Lahontan Regional Water Quality Control Board

Amended Waste Discharge Requirements for MP Materials LLC Mountain Pass Mine, San Bernardino County

**BOARD ORDER NO. R6V-2010-0047-A1
WDID NO. 6B362098001**

AMENDED REVISED WASTE DISCHARGE REQUIREMENTS

TITLE
PLANNED OPERATIONS
FIGURE 1.3 (REVISED DECEMBER 2025)

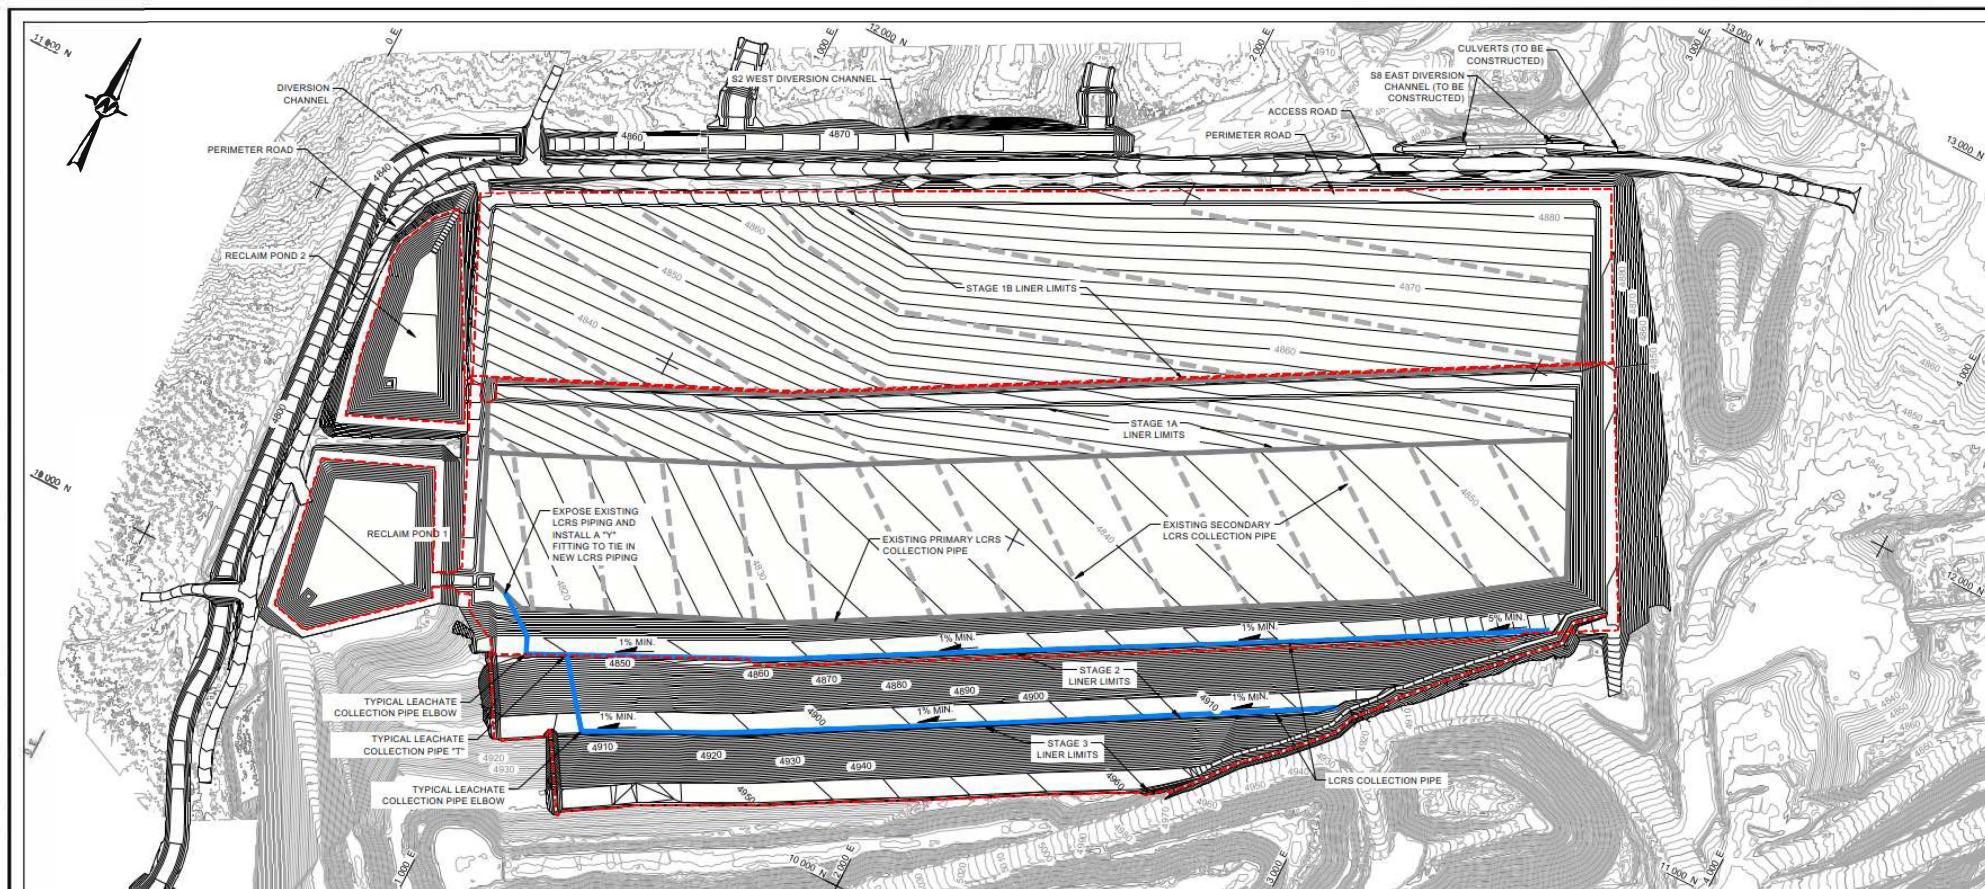
The approval of this amended Order would establish requirements regarding the construction and operation of Reclaim Pond 2 and other changes described in the ROWD/Design Plan submitted in 2025. These changes are not substantial changes to the project or to circumstance under which the project that would cause new significant impacts or increase the severity of impacts already considered. In addition, no new information of substantial importance has been received that shows that the project will have new significant impact or increase the severity of impacts already considered. The Water Board reviewed and considered the information in the EIR and MND before acting, and has concluded that no subsequent or supplemental environmental documents are required.

TITLE
NWTDF LCRS LOCATIONS
FIGURE 3 (REVISED DECEMBER 2025)

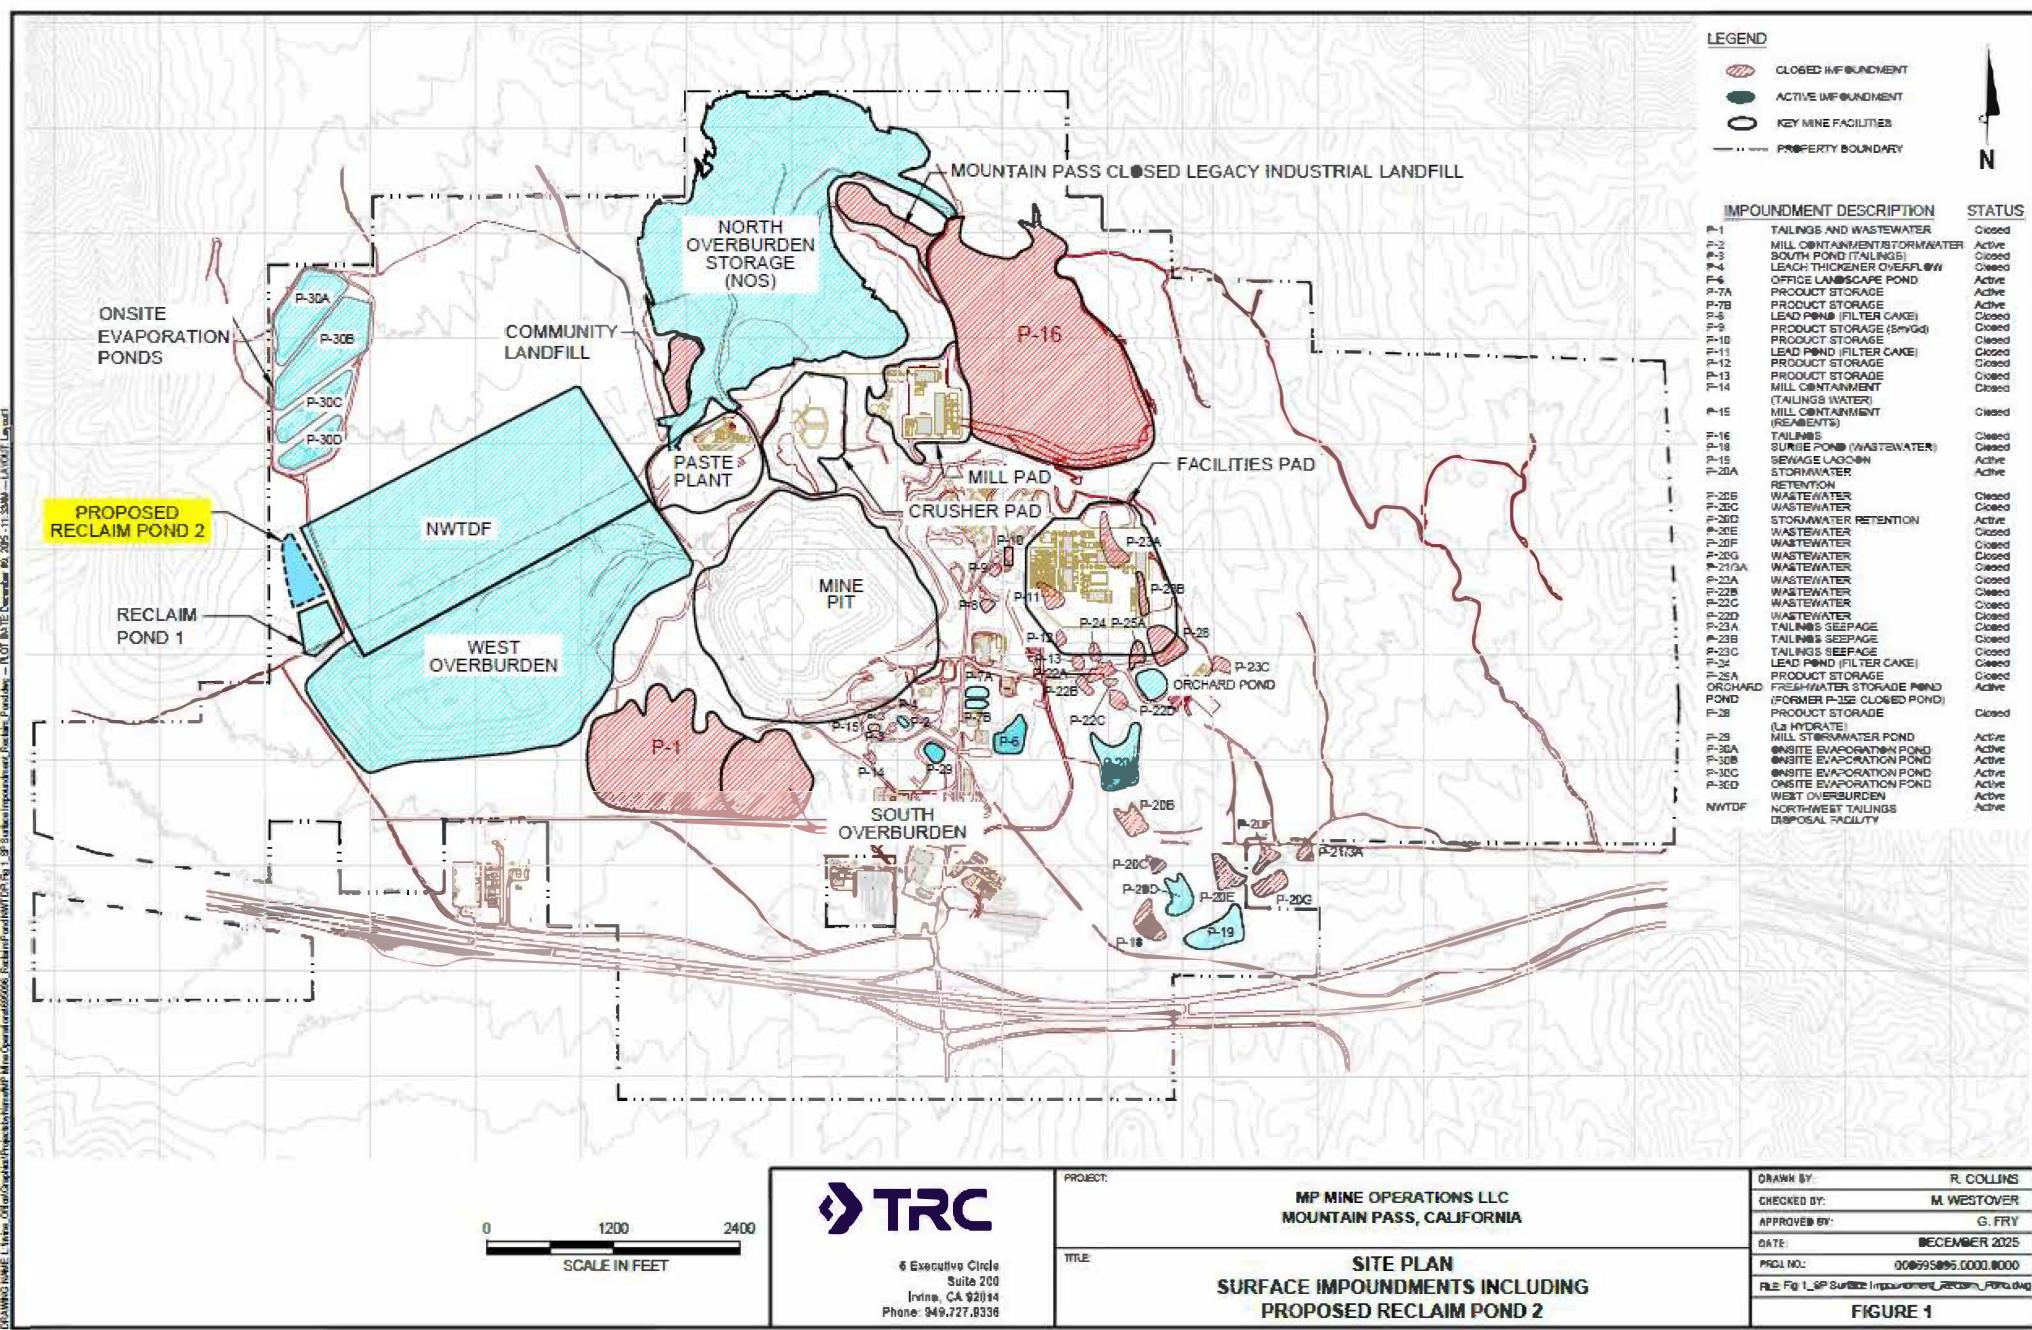
6. The Discharger must report leakage rates of the LCRS in the Reclaim and Clarification Surface Impoundments as specified in *Table 2 ACTION/RESPONSE LEVELS – LCRS FOR SURFACE IMPOUNDMENTS* in the MRP No. R6V-2010-0047. If the leakage rate to an LCRS sump in the Reclaim Pond or the Clarification Pond exceeds the applicable action leakage rate, the Discharger shall comply with the notice of evidence of response to exceeding the action leakage rate requirements in the MRP No. R6V-2010-0047.
